SEWAGE DISPOSAL SYSTEM

DEPARTMENT OF HEALTH AND MENTAL HYGIENE

ADDRESS 2555 Jennings Chapel Road, Woodbine, Maryland PHONE 489-4724

REPAIR - PURPOSE - TO SUPPORT BUILDING PERMIT # 34478 - REPLACEMENT OF EXISTING DWELLING.

46319

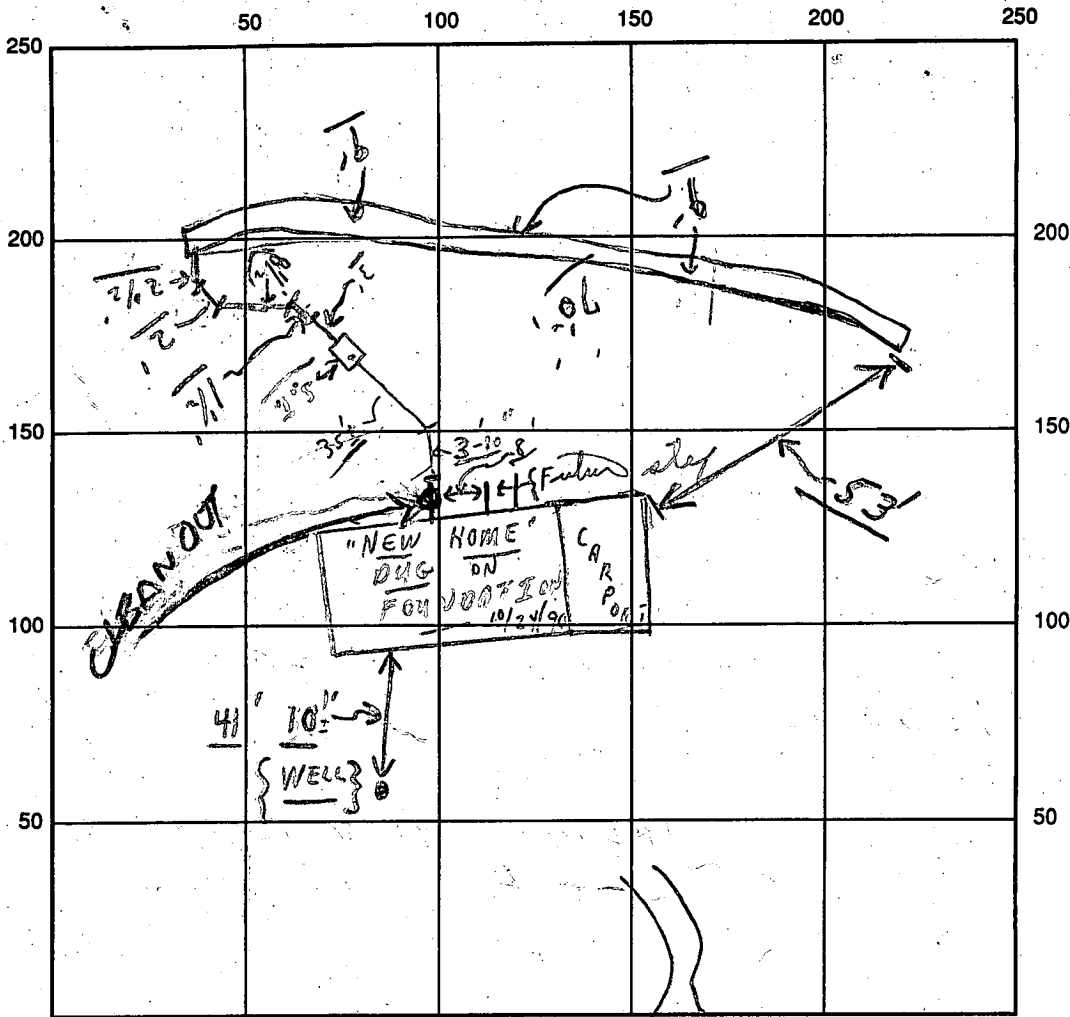
REMARKS: P.M. 10/24/90 No house connection - 5'± to house; tested
OK TO CONTINUE (70' of trench on); P.M. Paper on trench to 4" of
surface - Final except house connection this
date. C.B.D.

P.M. 10/24/90 No. W.P.E. YET!! C.B.D. HOUSE HOOK UP OK RW
DATE SYSTEM APPROVED 4/26/91 INSPECTOR Raymond Hodges
OUTSIDE PRIVY REMOVED RHODGES

SEPTIC SYSTEM PLANS

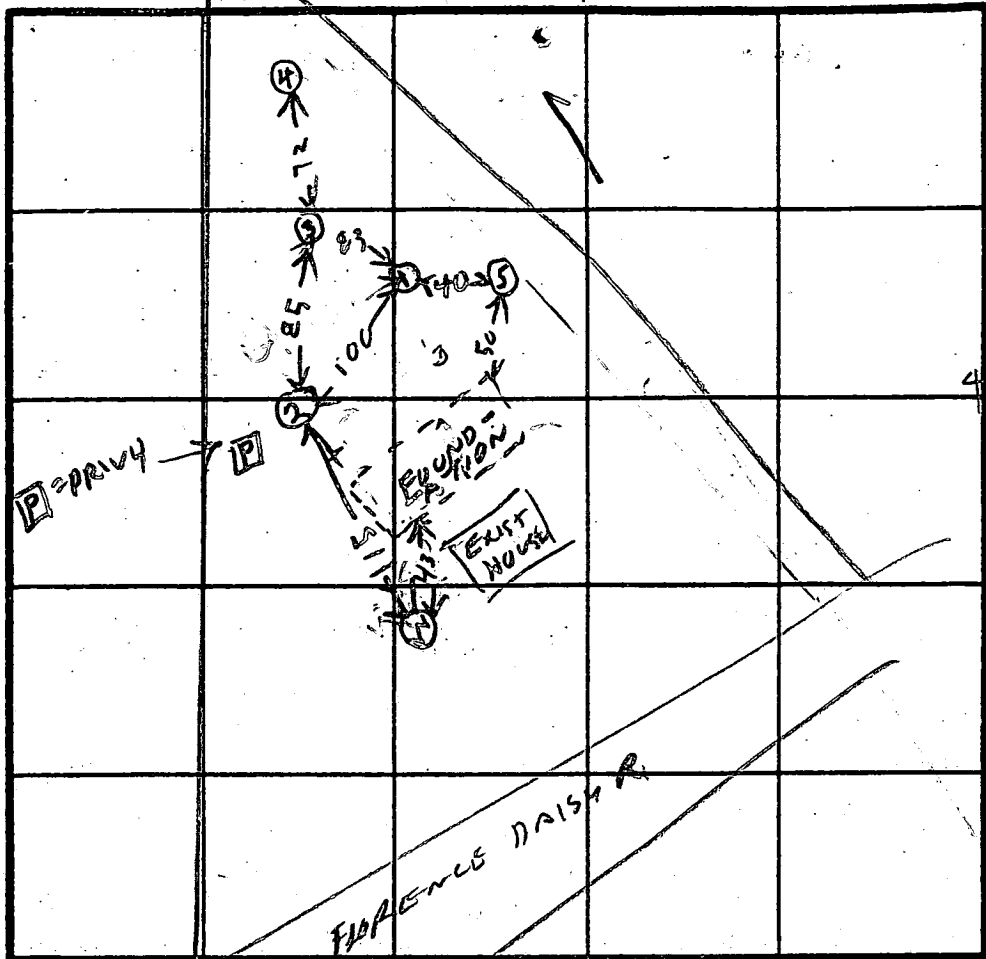
REASONS FOR REJECTION OR HOLDING 9/10/90 PERC OK NEED PERC CERT PLAT

REMARKS EXISTING WELL OLD HOUSE & PRIVY TO BE RAZED
